Product Change Notification / GBNG-16BGIH897

CCB 4628 and 4628.001 Final Notice: Qualification of STA as an additional assembly site for selected LAN9500A, USB2512B, USB2513B, USB2514B and USX2064 device families available in 56L VQFN (8x8x0.9mm) and 36L VQFN (6x6x1.0mm) packages.

PCN #: GBNG-16BGIH897

CCB 4628 and 4628.001
Pre and Post Change Summary
PCN #: GBNG-16BGIH897

56L VQFN

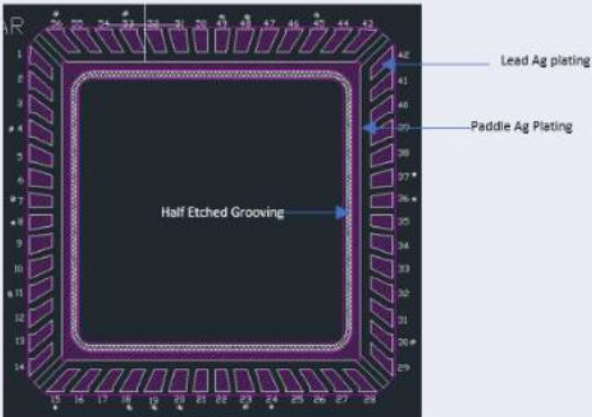
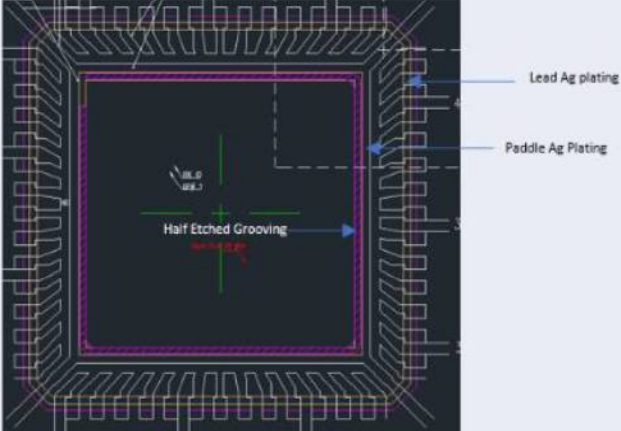
ASE	STA
LF Definition – Double Ring Plating	LF Definition – Double Ring Plating
<p>*Plating on Lead finger and plating surrounding LF Paddle (Purple shaded area)</p>  <p>Lead Ag plating</p> <p>Paddle Ag Plating</p> <p>Half Etched Grooving</p>	<p>*Plating on Lead finger and plating surrounding LF Paddle (Yellow outline area)</p>  <p>Lead Ag plating</p> <p>Paddle Ag Plating</p> <p>Half Etched Grooving</p>

36L VQFN

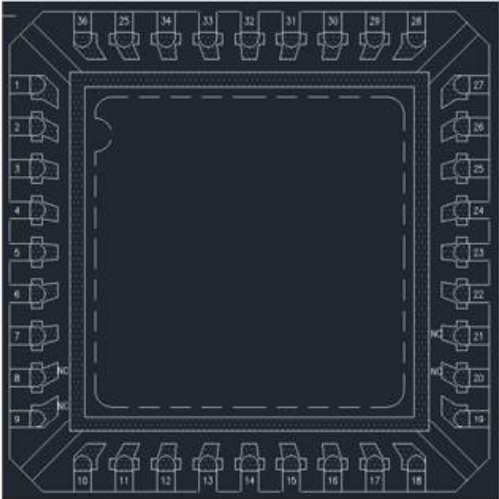
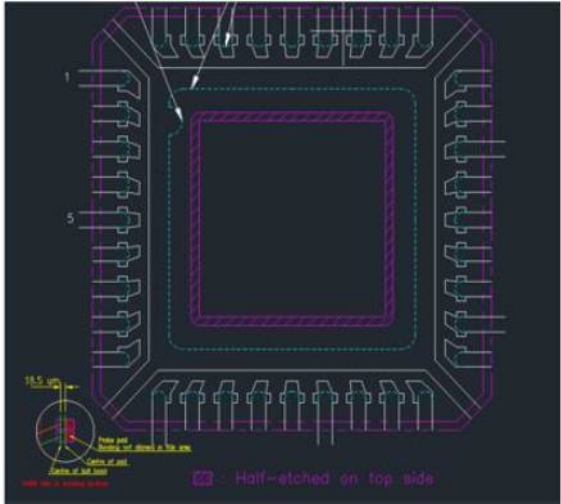
January 27, 2022: Re-issued final notification. Corrected lead frame drawing for ASE 36L VQFN in the Pre and Post Change summary attachment.
